MAH-680-7.37

CITY OF YOUNGSTOWN, BOARDMAN TOWNSHIP
 MAHONING COUNTY

RESURFACING IR 680, SLM 7.31 TO SLM 12.00, IN MAHONING COUNTY, INCLUDES MINOR REHABILITATION BRIDGE WORK TO 9 STRUCTURES.

TITLE SHEET

TYPICAL SECTION 2 INCLUDES ACCELERATION LANES, DECELERATION LANES, AND GORES. SEE PG. 20 & 21 FOR ASSOCIATED CADD GENERATED AREA.

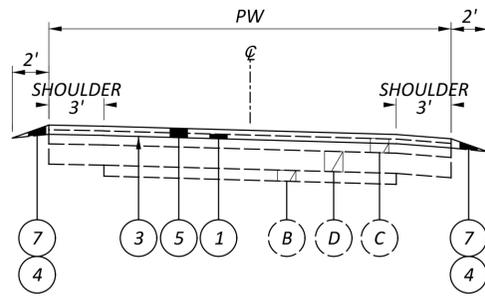
— changed asphalt type

TYPICAL SECTION 5: RAMP, TWO CURB

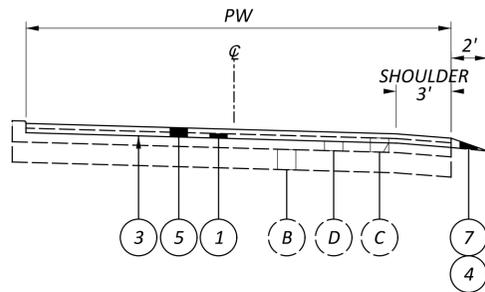
adjusted widths

DETAIL A
CONCRETE DECK WITH
DEFLECTOR PARAPET

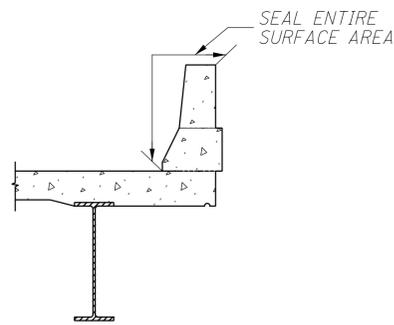
changed items and quantities

modified descriptions
